Addendum No. 4

Reference: New Ogden Second District Juvenile Court
Administrative Office of the Courts – Ogden, Utah
DFCM Project No. 08284150

Addendum 003

project:	Ogden Juvenile Courthouse	**project no:**	12500
date:	2013-09-10	**no. pages:**	35
owner:	Administrative Office of the Courts		
contractor:

D1 SF504 HSS COLUMN TO HSS BEAM CONNECTION
NO SCALE

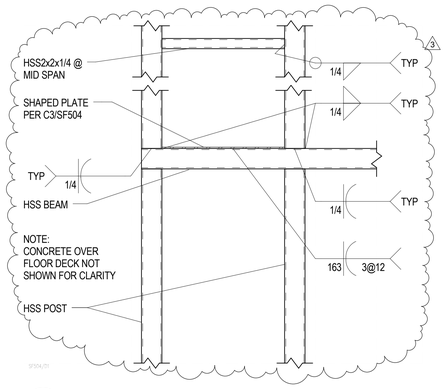
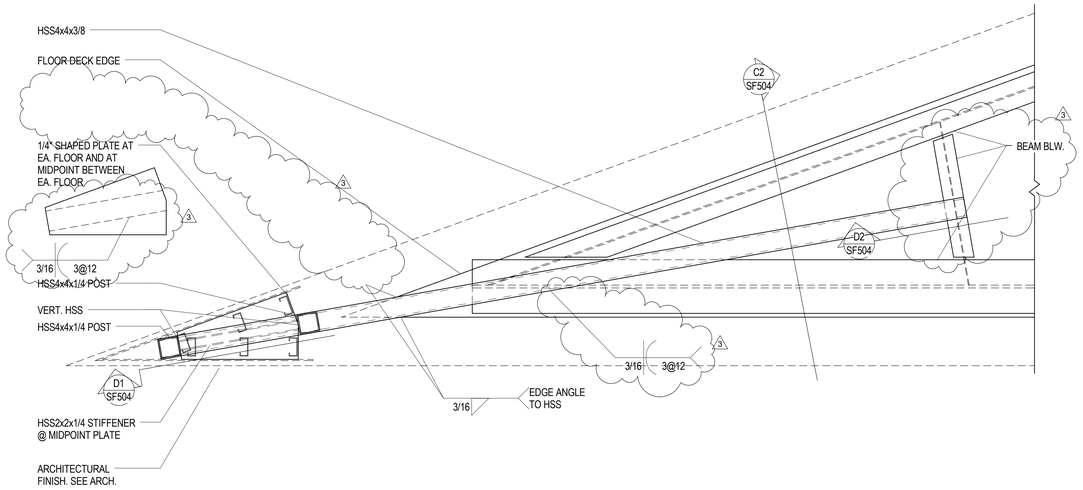
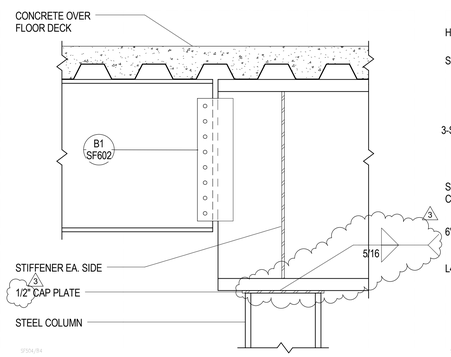
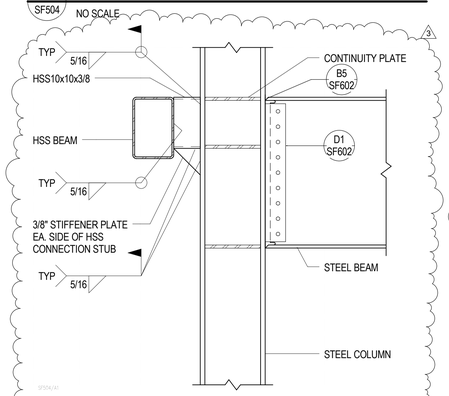
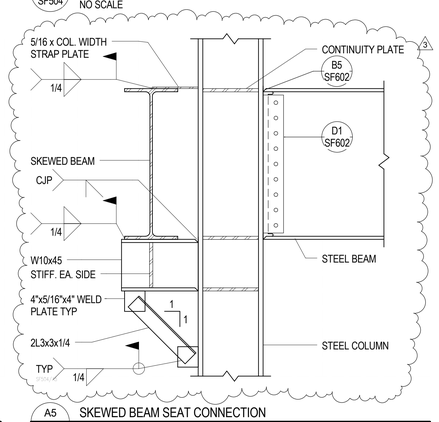
Sheet SF503 and SF504
Several revisions to clarifying existing details

C4 / SF515 HSS BRACE TO HSS BEAM AT PARAPET SUPPORT
NO SCALE

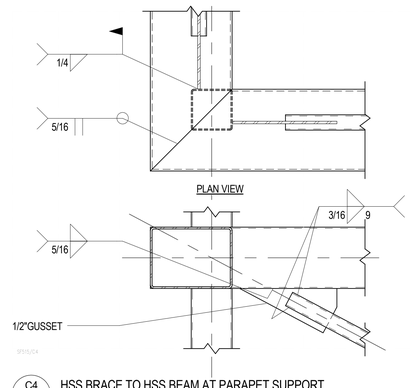
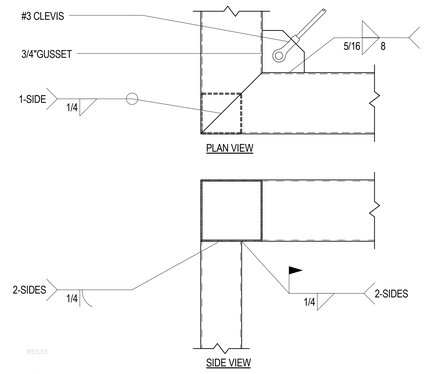
Sheet SF515, SF516, SF517
Several revisions clarifying several details

B2 SF601 TYPICAL STEEL BASE PLATES - PLAN VIEW
NO SCALE

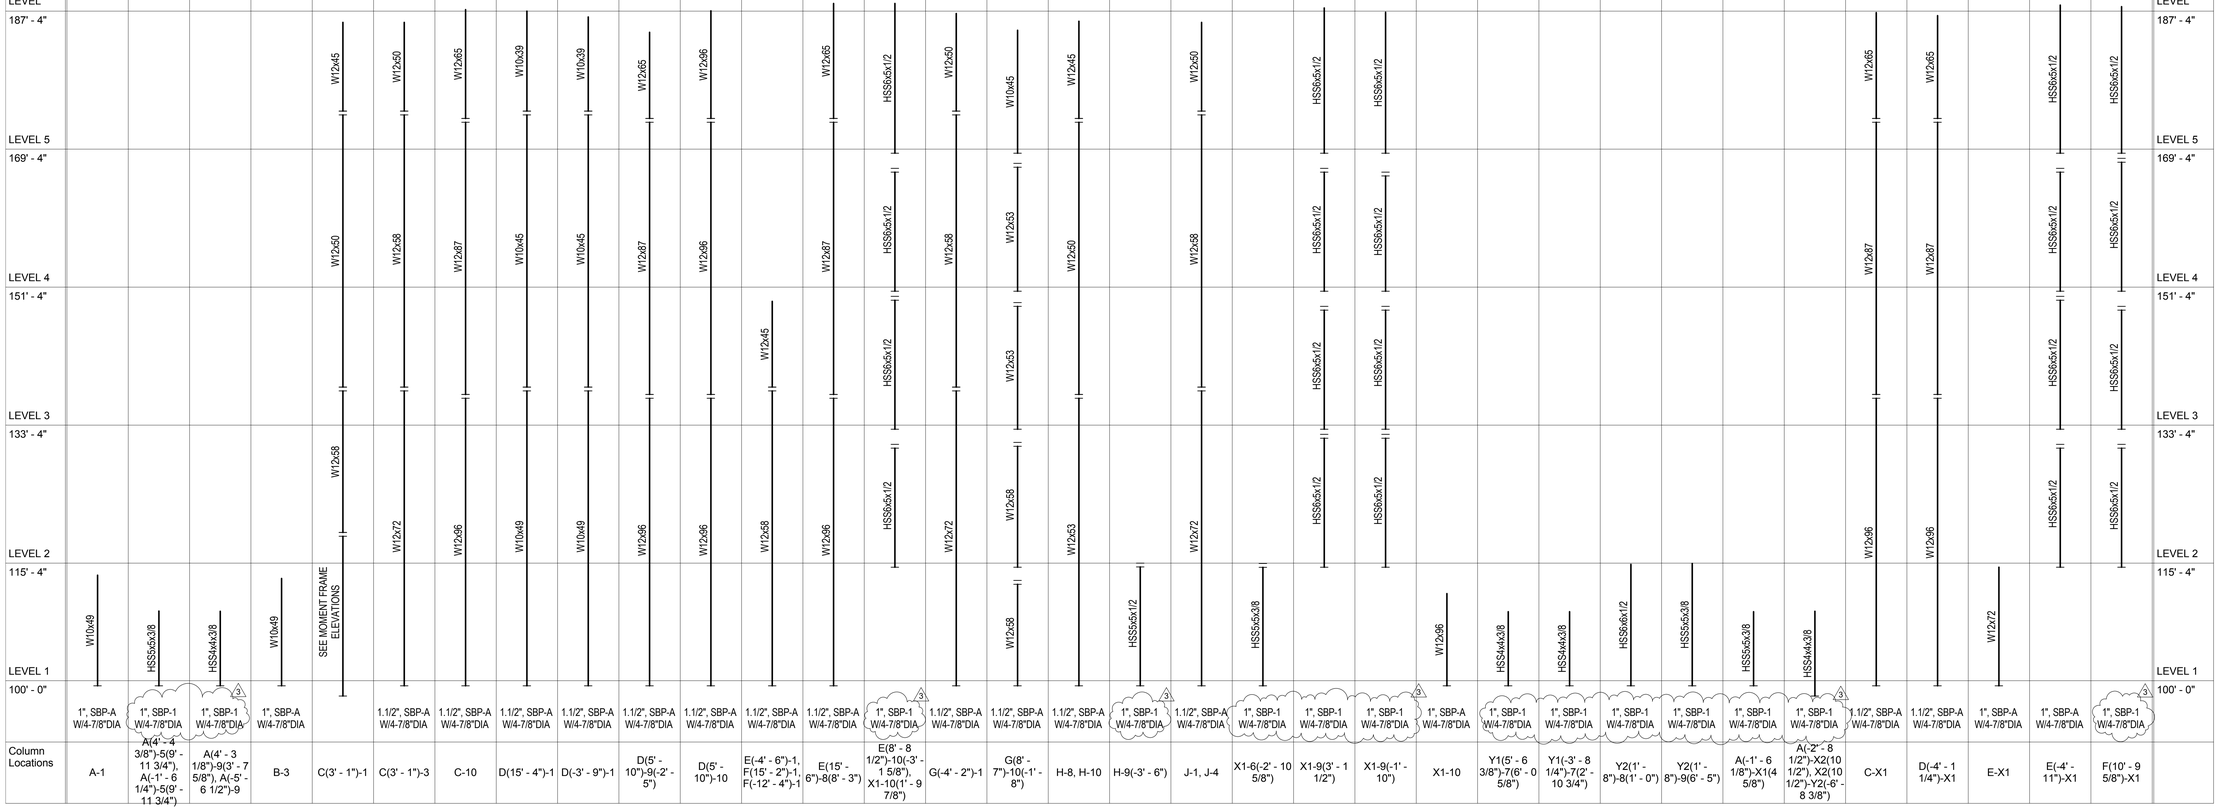
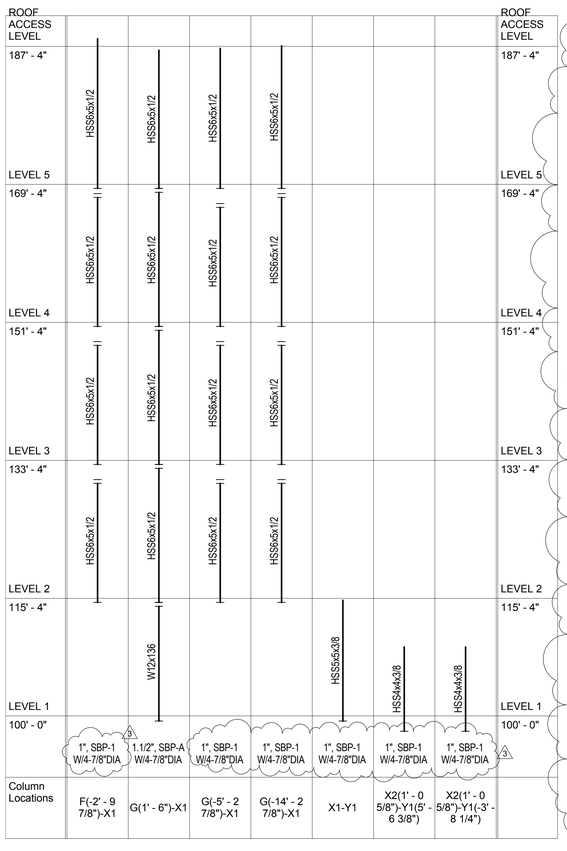
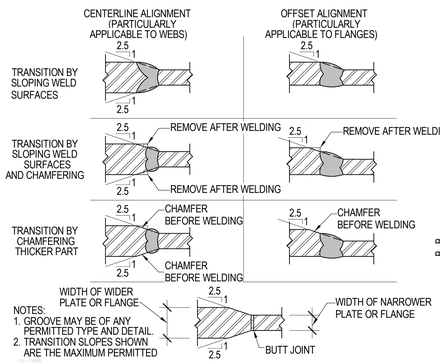
Sheet SF601
Added detail A2/SF601
Clarify some base plate layout and bolt patterns for gravity columns.

A1 / SF602 TYPICAL STEEL BEAM BEARING ON STEEL COLUMN
NO SCALE

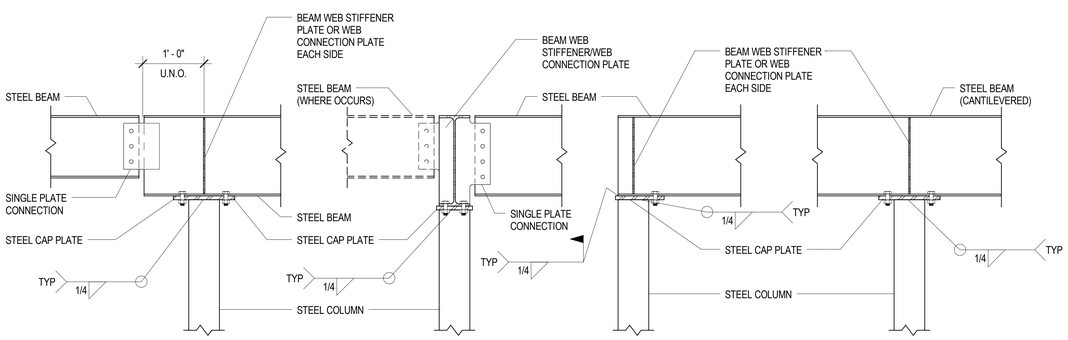
Sheet SF602
Revise detail B1, adding to schedules complete list of drag beams that where shown on plans but not included in detail schedule.
